Service Bulletin

Bulletin No.: PIT6452

Subject: Poor Heater Performance On Drivers OR Passengers Side

7020910

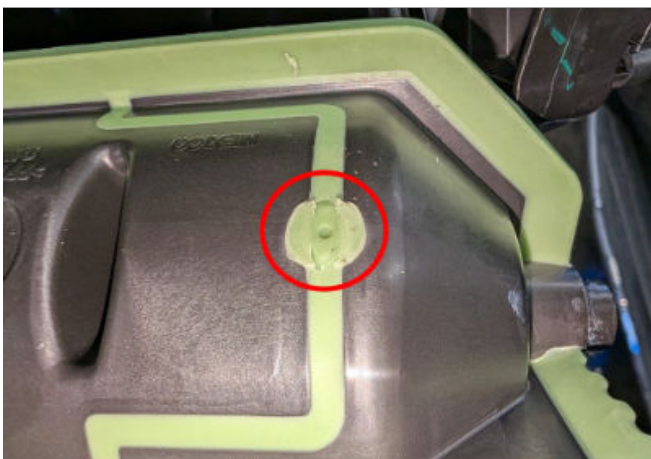
- Access the view through the upper vents or the HVAC evaporator temperature sensor openings
- Using a borescope, inspect for a disconnected temperature door link.
- Move both the driver's and passenger's temperature doors through their full range of travel while monitoring with the borescope.
- Watch for any binding or resistance that may cause the white temperature door link to separate from the doors or produce a popping noise.

If any door exhibits these symptoms, proceed to Step 2.
